RE: JMC Project 13021
Route 17K VW Dealership
Route 17K
Town of Newburgh, NY

Conceptual Approval

We are pleased to submit the following drawings and documents for the continuation of review of the Volkswagen of Newburgh project located on Route 17K:

NO.	REVISION	DATE	BY	DRAWN	APPROVED	PR
				JE		
SCALE: AS SHOWN DATE: 11/07/2013 PROJECT NO: 13021 DRAWING NO: SP-1 PREVIOUS EDITIONS OBSOLETE

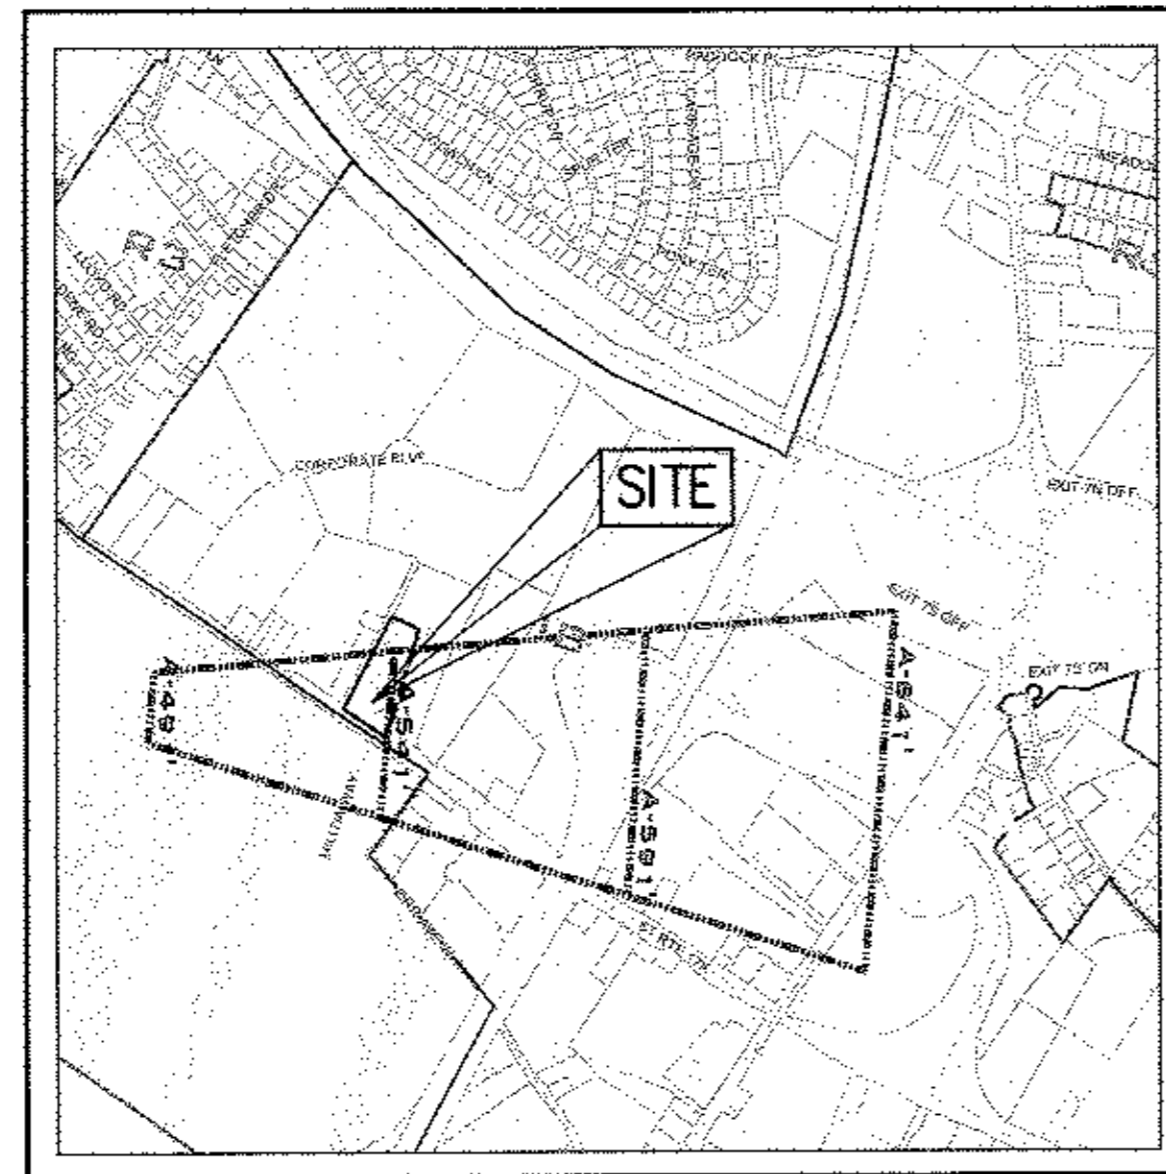
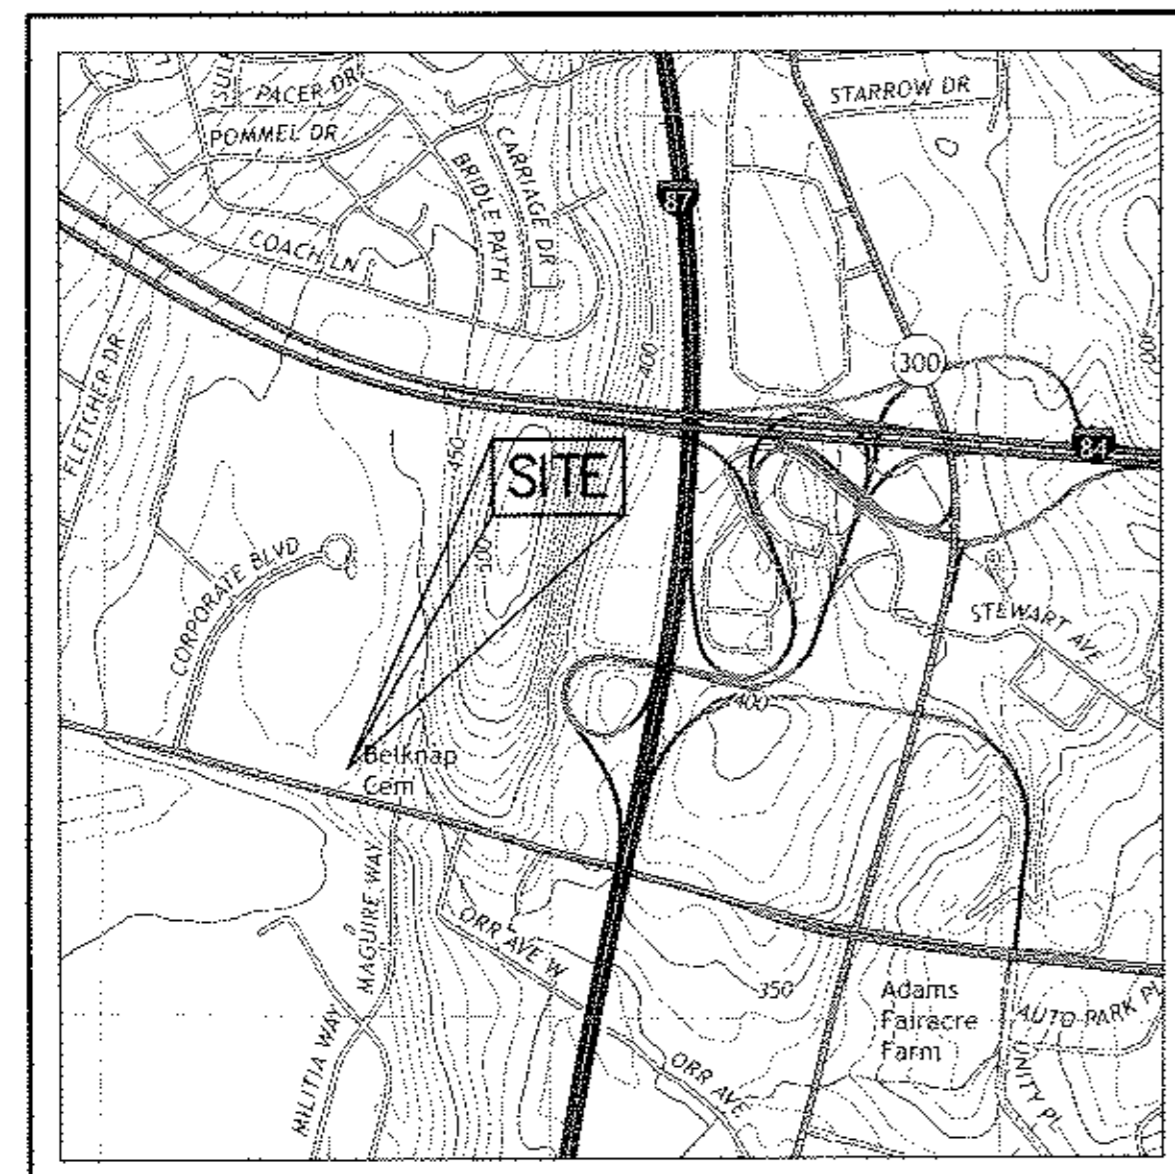
Comment No. 5

The parking calculation table should show how the applicant came up with the 237 spaces.

The Parking calculation has been broken down on the Cover Sheet, Note No. 7. The amount of customer, service, employee and new car inventory parking spaces have been noted.

DRW: JE APPROV: RR
 SCALE: 1" = 30'
 DATE: 11/07/2013
 PROJECT NO: 13021
 DWG: 100-010 GRADING
 DRAWING NO: SP-4

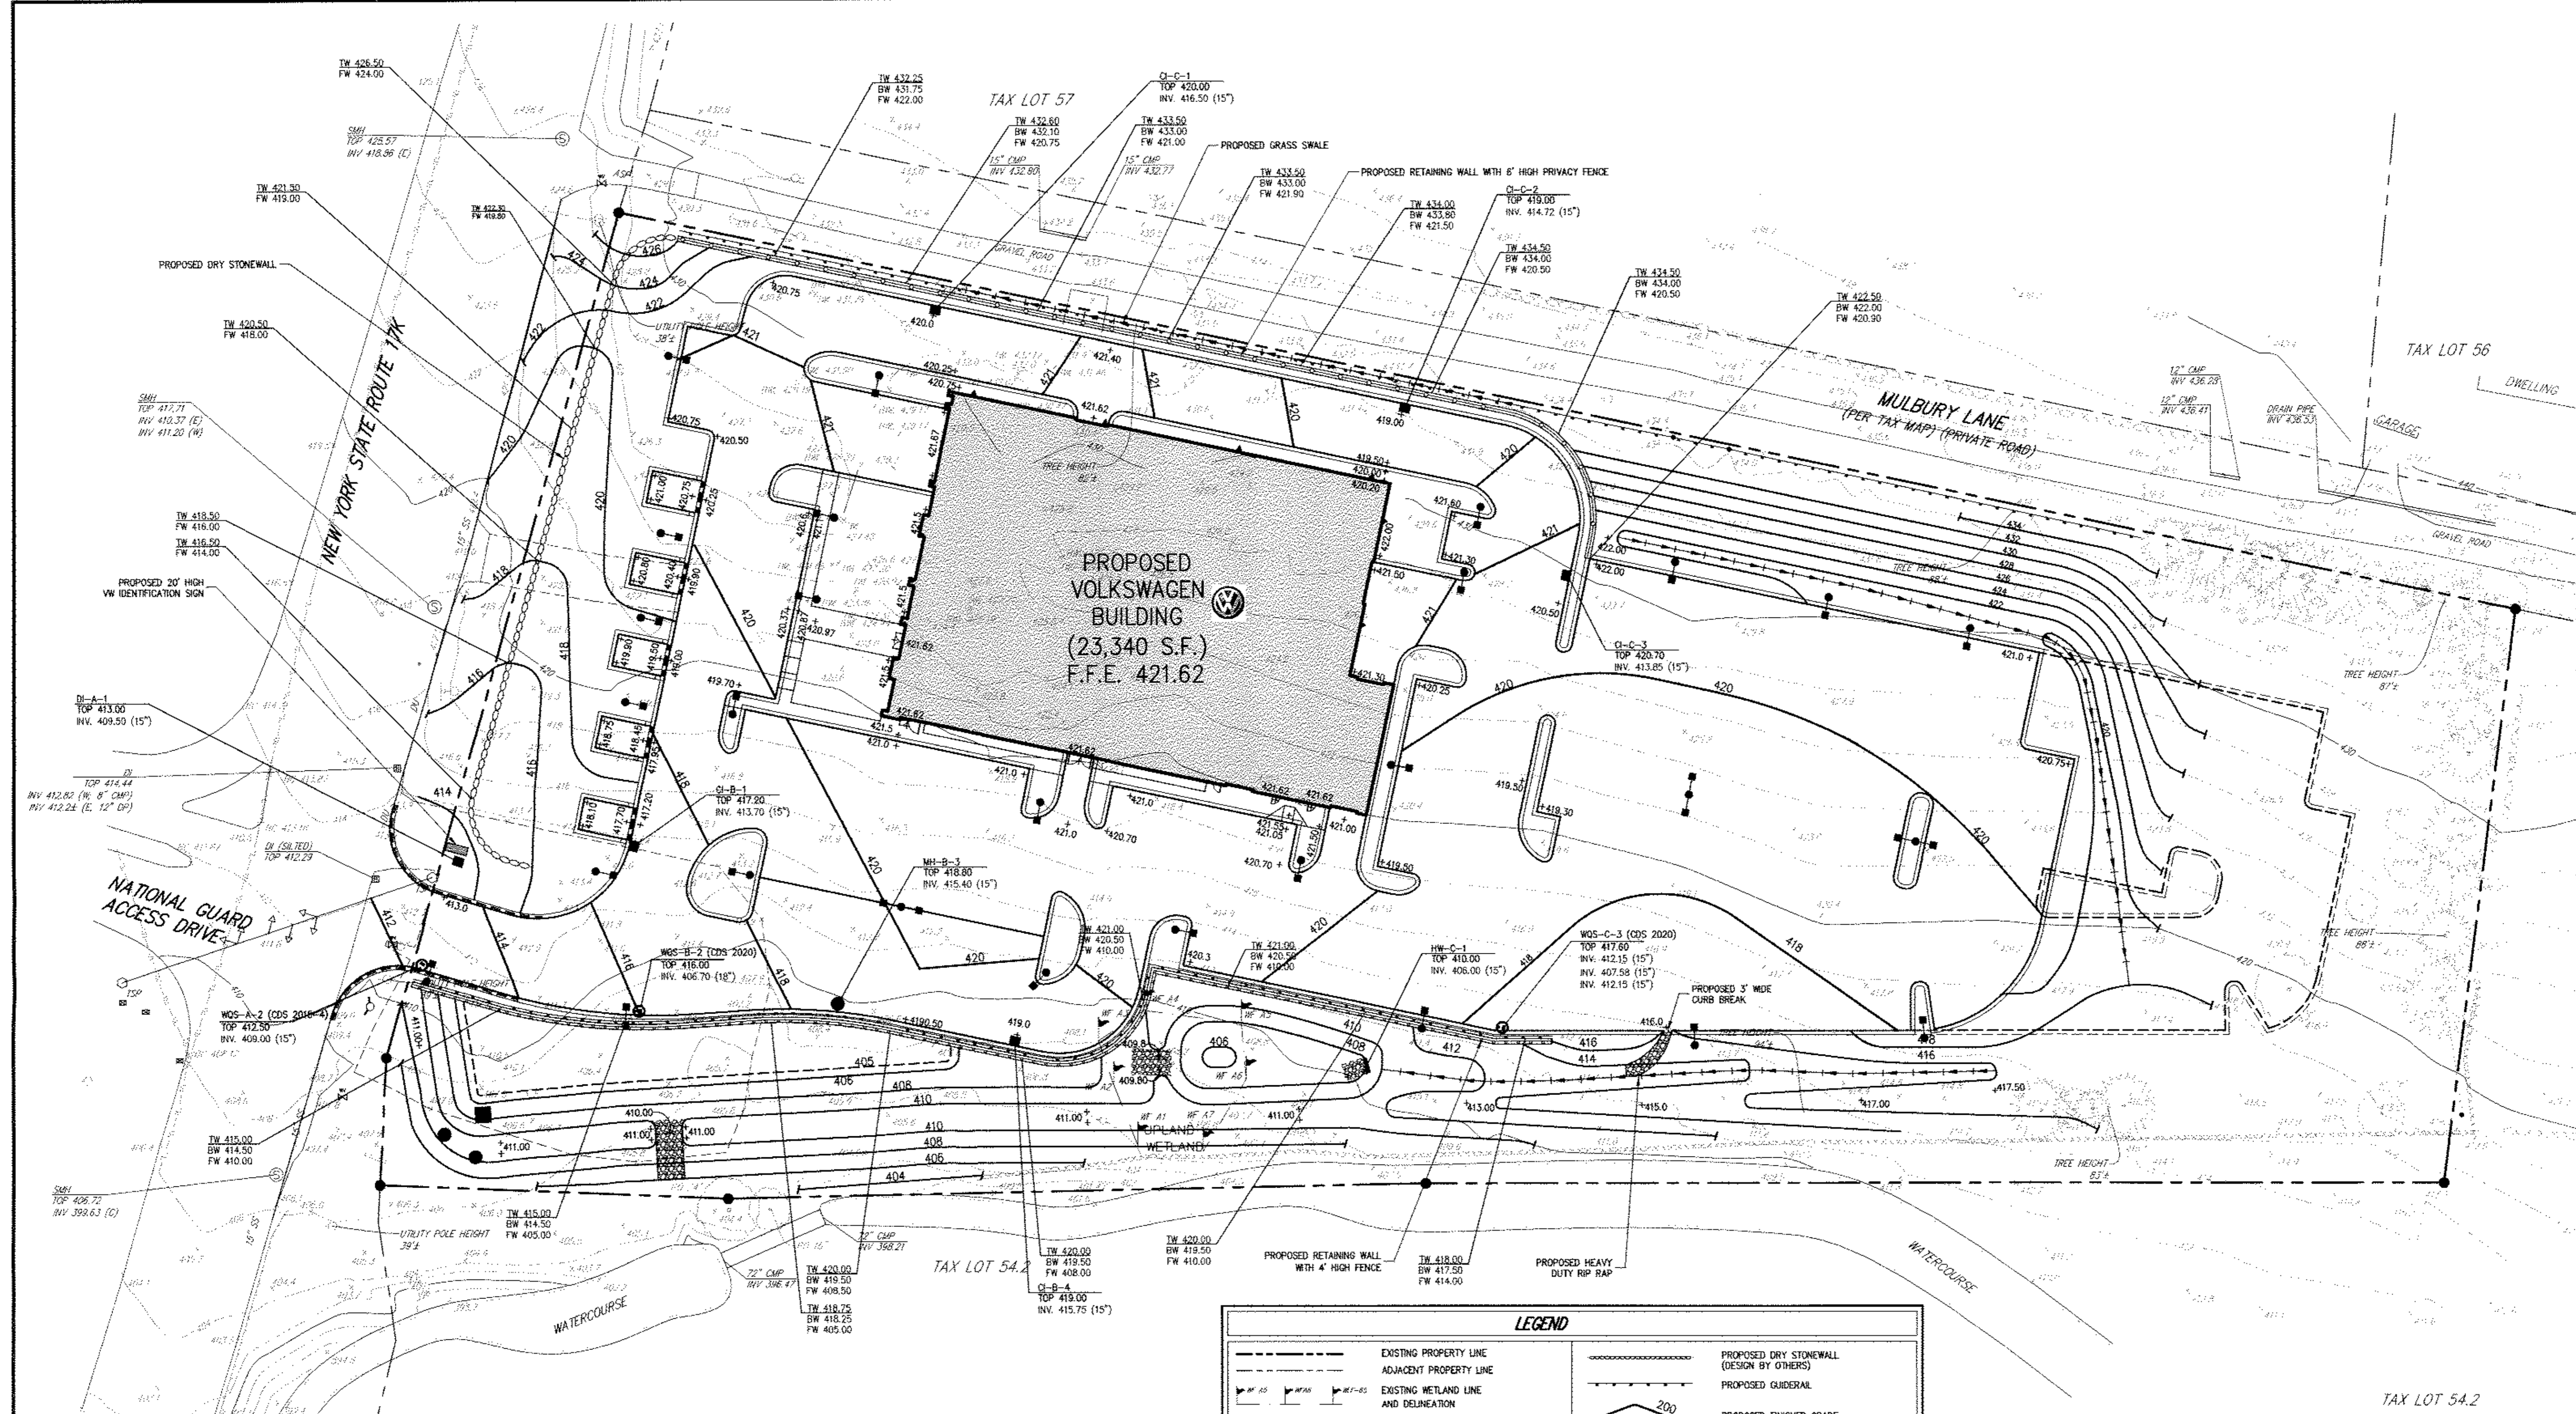
Comment No. 7

The front six inventory spaces have a retaining wall screening them from Route 17K. Is this retaining wall necessary for construction of the lot or for aesthetic purposes? Parking in the front yard should be screened with either landscaping or a wall of some sort to meet the intent of the Design Guidelines.

The retaining wall/grading design of the project is illustrated on Drawing SP-4 "Grading Plan". A retaining wall along the property line adjacent to Mulbury Lane is required in order to meet existing grades. A dry stonewall is proposed to be constructed along the front property perimeter and landscaping as noted on Drawing SP-7 "Landscape Plan".
